| Delegated Report | | Analysis sheet | Expiry Date: | 21/01/2020 |
| Kate Henry | | | 2019/4214/P | |
| 28 Harley Road London NW3 3BN | | | Please refer to draft decision notice | |
| Formation of a new driveway access including a new vehicle crossover; associated boundary treatment alterations; resurfacing of the existing driveway | | | | |

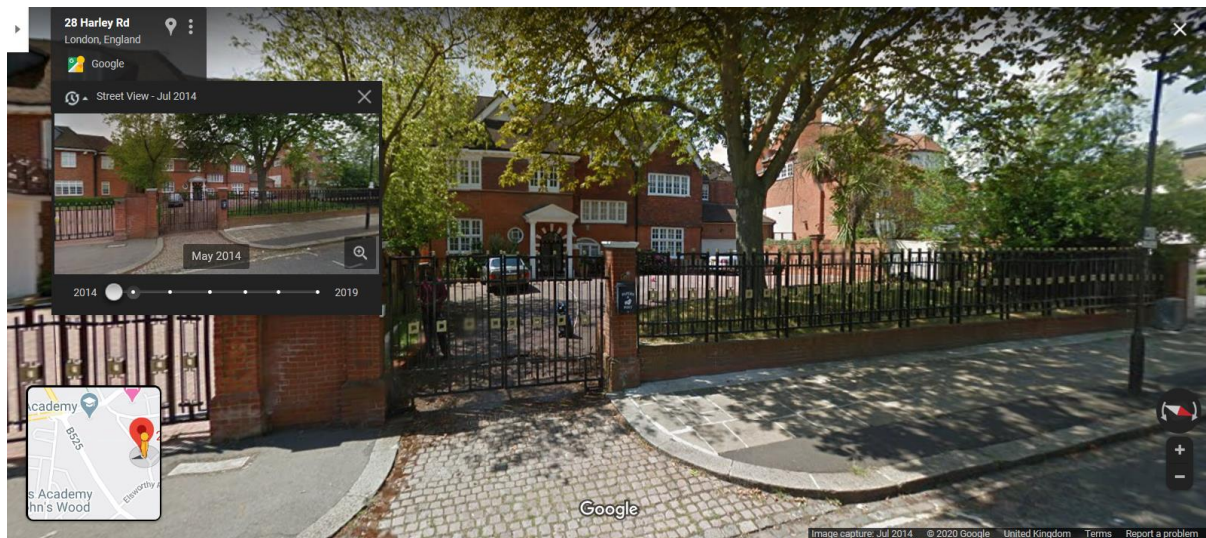
- 3.17. The existing area of planting, which is roughly triangular in shape, measures approximately 95 square metres and when the hoarding is removed from the frontage, it would be possible to appreciate this area of planting from the street (as shown in the Google

- 3.18. The proposals would see a reduction in the area of planting from approximately 95 square metres to approximately 55 square metres (a 58% reduction) (the area of planting between the two entrances would measure approximately 30 square metres and the area of planting along the northern boundary of the application site would measure approximately 25 square metres) and the two retained areas of planting would be separated by hardstanding associated with the new access to the site. The resultant frontage of the property would be largely dominated by hardstanding and this would be apparent when viewed from the street, thereby causing harm to the character and appearance of the Elsworthy Conservation Area.

Fig 1 1163-211A_Proposed Driveway and Entrance Plans

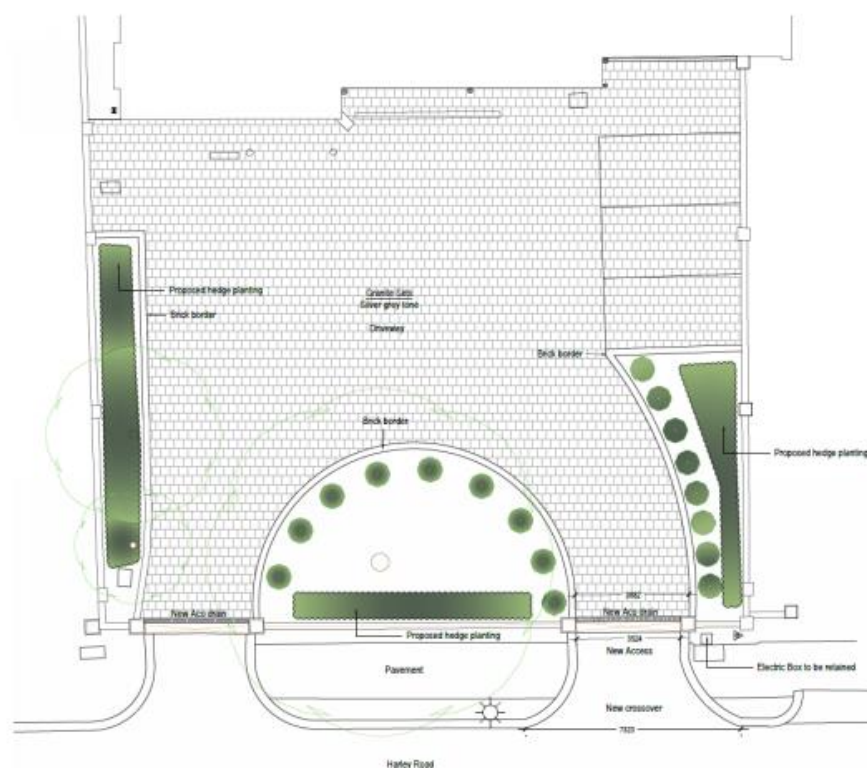
- 4.7. The report acknowledges that the removal of Trees T4, T5 and T6 will have “a minor negative impact on the local landscape and conservation area due to a reduction in ornamental ‘garden’ vegetation forming part of the streetscene along Harley Road” (paragraph 4.3); however, the report then justifies the removal by noting that “a new area of landscaping is included in the scheme to replace trees and shrubs lost along the north-west site boundary”. The Council disagrees that a new area of planting is being provided; rather the existing area of planting is

being significantly reduced in size and split into two by the creation of the new access. Also, the report seems to assume that the area of “new landscaping” will be larger than that actually proposed.

4.11. However, as noted above, the Arboricultural Report seems to assume that the resultant area of landscaping would be larger than that actually proposed as part of the application and therefore the Council considers that the impact on the root protection area is likely to be greater than stated in the report. The Horse Chestnut makes a positive contribution to the character and appearance of the application site, the streetscene along Harley Road and the Elsworthy Conservation Area and its loss if it were to be harmed by the proposed works would cause harm to the character and appearance of the conservation area. The loss would also be harmful in biodiversity terms. The application is therefore also refused based on the lack of sufficient information to properly assess the impact on the retained tree.
